84 Swallowfield Way, Hayes

Response to London Borough of Hillingdon and Transport for London Comments

N03/226977

August 2023

Figure 2: Insert of Datashine Census Travel to and from Work for Bus/Coach

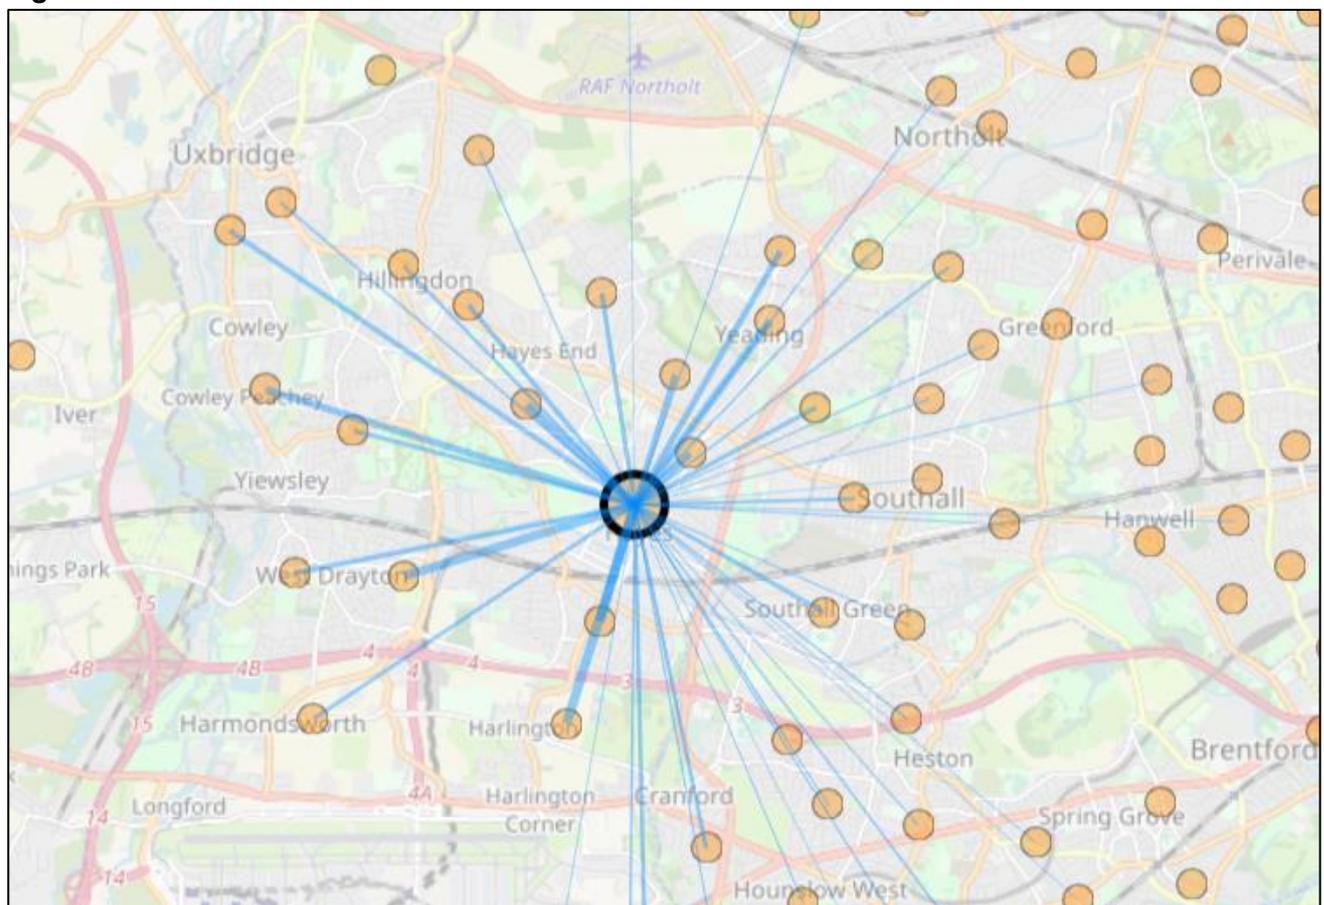
“TfL request that further commentary is provided in regard to the nighttime assessment in particular to Routes 1, and 5.”

9. It was determined unnecessary to evaluate Route 5 as part of the night-time assessment as it is considered that employees travelling to the site at nighttime would prefer a bus route with a stop closer to the site. The closest bus stops to the site are on Dawley Road, an 8-minute walk from the site. These bus stops on Dawley Road can be reached via Route 1 as detailed above and in the TA. The bus stops at the Square are a 13-minute walk. The route to the bus stops along Dawley Road is considered a more attractive route, with the U5 bus service stopping at both the Square and Dawley Road bus stops.

10. Furthermore, the total number of employees who would need to travel via route 5 during nighttime hours equals circa 10 employees. This is based on the number of people anticipated to commute to the site via bus over the course of the 24 hour day which equates to 212 employees. It is assumed that 71 employees would travel at night-time, for the night shift at the proposed development.

11. The Datashine census commuting tool has been used to understand where people travel from, via bus, as shown in **Figure 2** below. The percentage of people who would likely use the Square bus stops equate to circa 14% of all employees commuting by bus.

12. As such, of these 71 employees, circa 14% who travel by bus would access bus services from the Square. This equates to circa 10 people who would need to travel via route 5 during nighttime hours. On this basis the route does not warrant large scale upgrades.

Figure 4: HGV Routing Plan

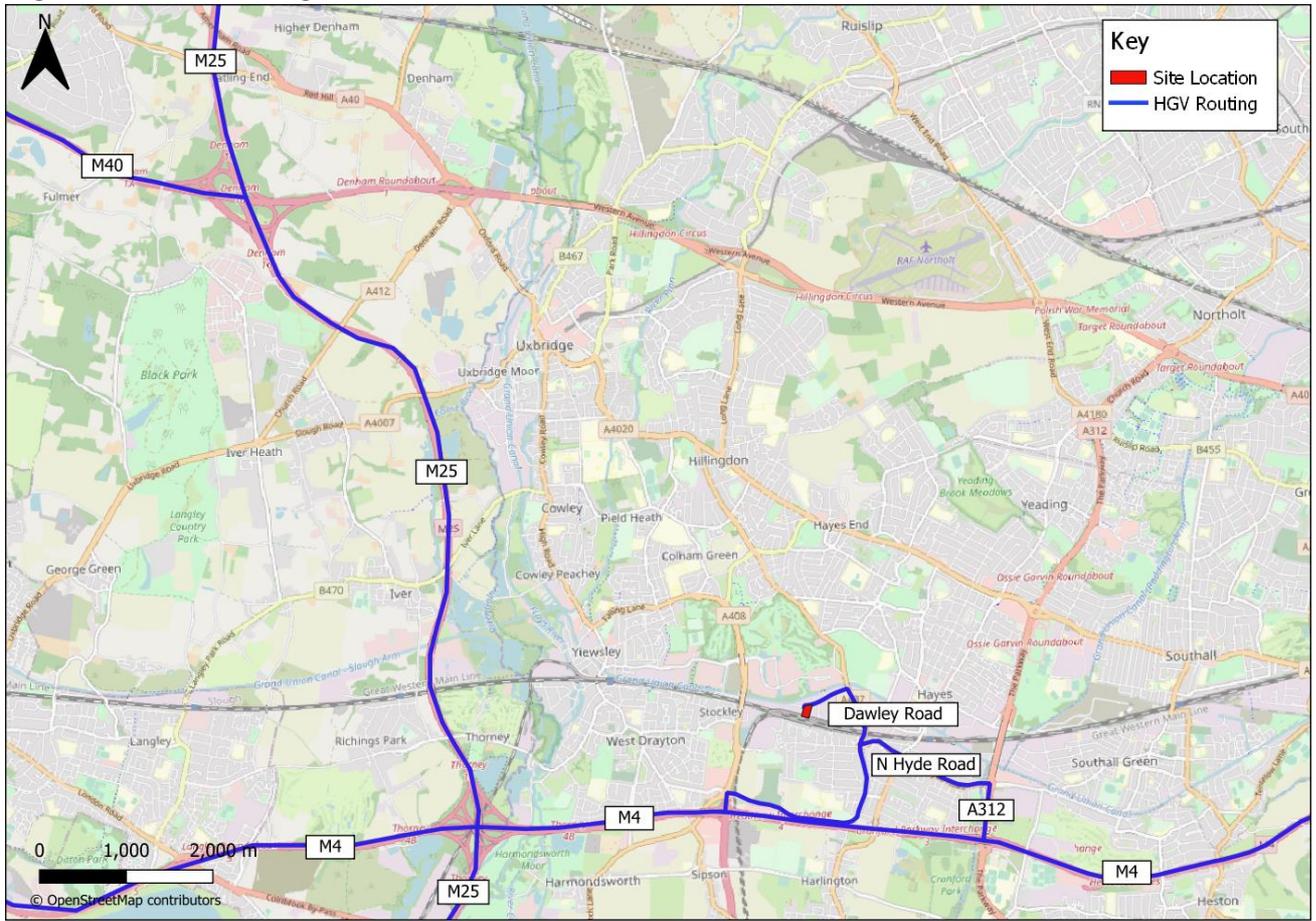
“TfL request that HGV vehicle routing to and from the site is provided in order to establish the overall impact at key junctions and whether any contributions may be required towards road safety improvements.”

18. A google journey time routing exercise has been undertaken to understand which routes are likely to be undertaken by HGV delivery drivers to the M4, M25 and M40.
19. These routes as shown in **Figures 5 to 9** indicate that all HGVs would route south as the M4 provides the quickest route further afield and is the quickest connection to the strategic network from the site.
20. The routes that HGVs are most likely to take are outlined in **Figure 4**.

21. The routes shown in **Figure 4** have been determined using Google Maps journey times. These journeys are shown in **Figure 5 to 9** below.

Figure 10: Location of Modelled Junction

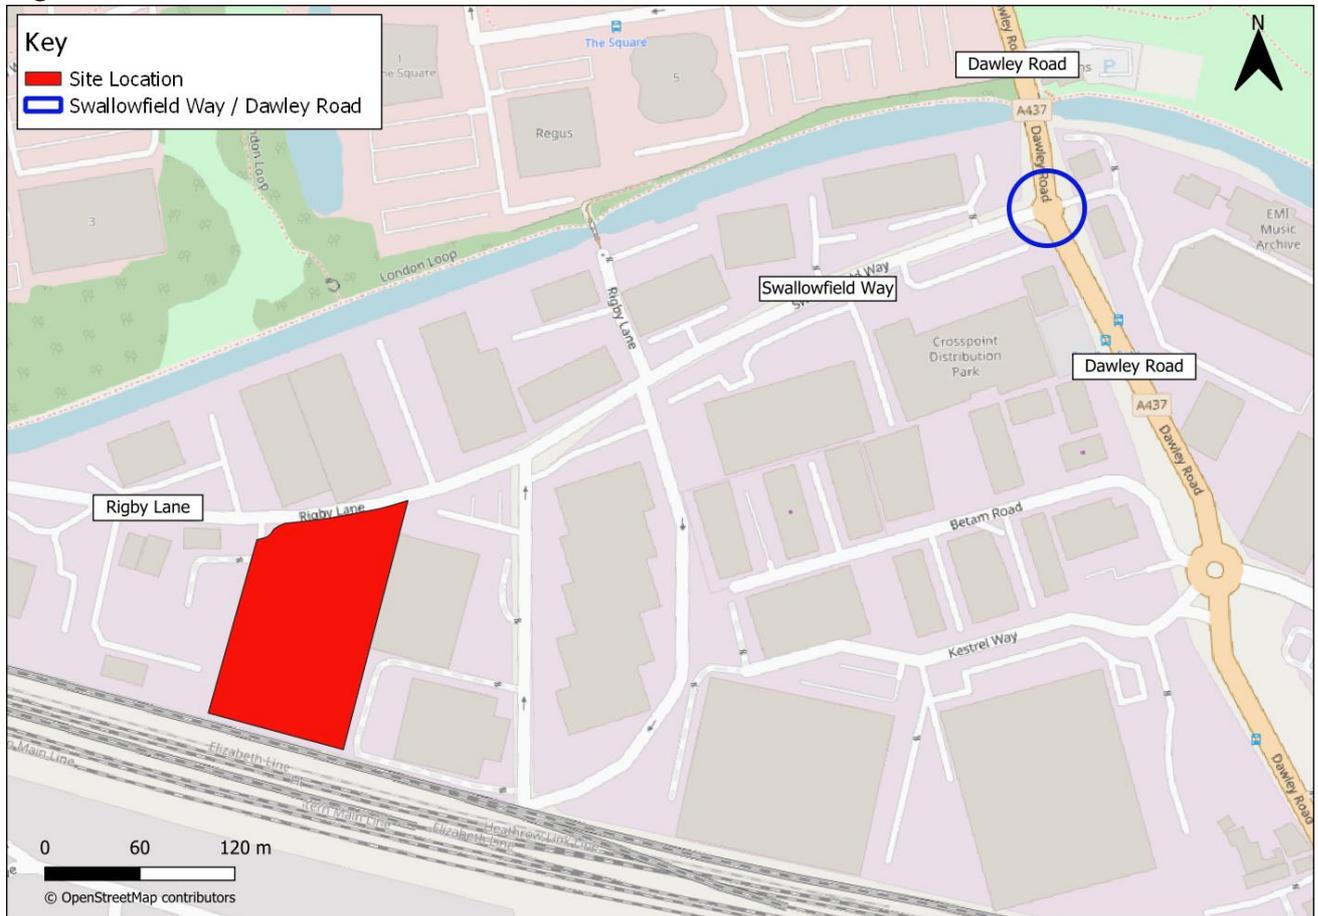
“TfL are awaiting the TA addendum to assess impacts on the local junctions and whether a financial contribution is required.”

41. This response note contains the highway impact assessment that would otherwise be provided within a Transport Assessment Addendum. The highway impact assessment focuses on the Dawley Road/Swallowfield Way roundabout as all site traffic would route through this junction.
42. This roundabout can be seen in relation to the site in **Figure 10** below.

- 62. The capacity modelling presented above demonstrates that the junction operates within capacity with the addition of development traffic.
- 63. In the worst-case scenario, in the AM peak hour, Dawley Road North experiences an increase in RFC from 0.86 to 0.91. There is also an increase in the delay from 26.65 seconds in the baseline scenario to a 38.32 second delay with the addition of development traffic. This also leads to an increase in queuing at the arm from 5.6 to 8.1 vehicles. This is not considered to result in a severe impact on this junction.
- 64. Beyond this junction the development traffic will disperse across the network and as such the development impact on each junction would significantly decrease. Therefore, no contribution to any wider junction improvements is required by the proposed development.

DRAWING TITLE: **Pedestrian movements**

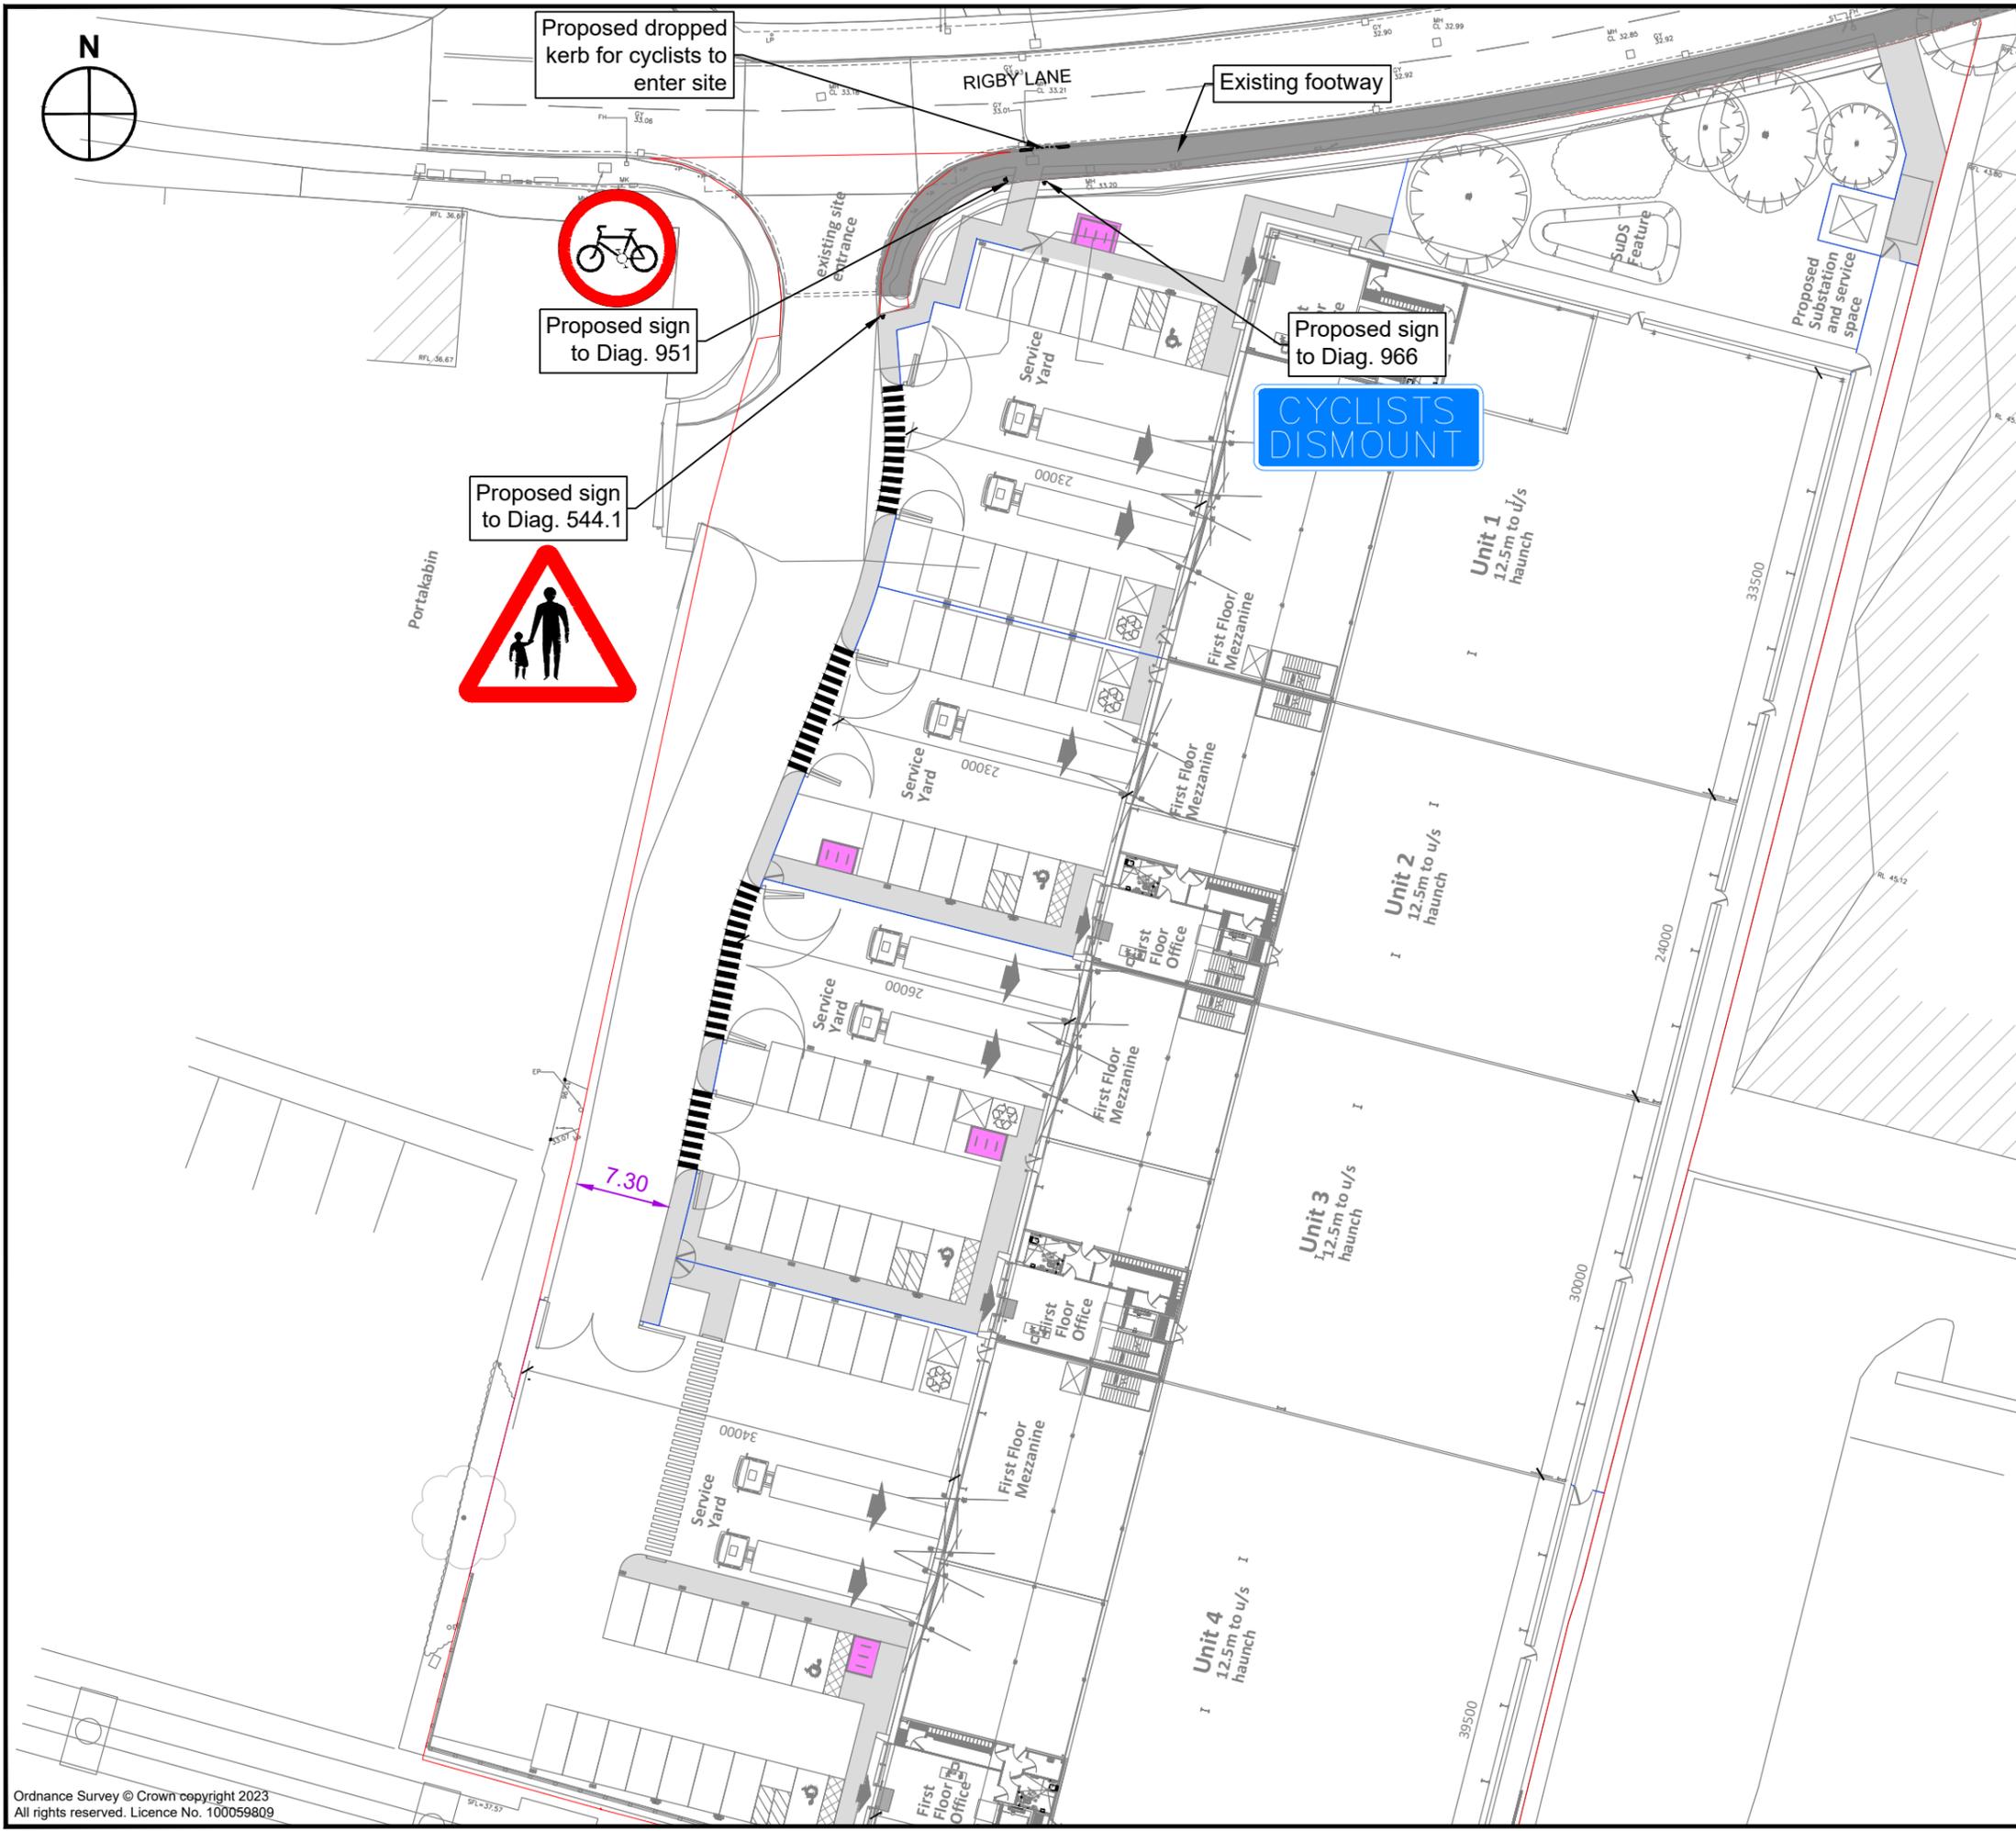
“The Highway Authority believes for the development to provide more safe and convenient access for pedestrians on-site that zebra crossings should be created at the front of each service yard for units 1-3.”

“The Highway Authority would strongly recommend that a segregated cycle lane into the site is provided for cyclists, as this will support active modes of travel to the site and meet the Healthy Streets Approach”

16. The site plan has been updated based on comments received from TfL and LBH. The updates include the provision of zebra crossings at the front of each service yard for units 1-3.
17. With regard to cycling, it is proposed that a dropped kerb will be provided at the pedestrian access and a sign indicating to cyclists to dismount and walk their bikes to the cycle parking. Additional signage will also be provided at the vehicular access warning drivers of the potential presence of pedestrians and people walking their bikes in the area. These improvements are illustrated on the drawing provided within **Appendix A**.
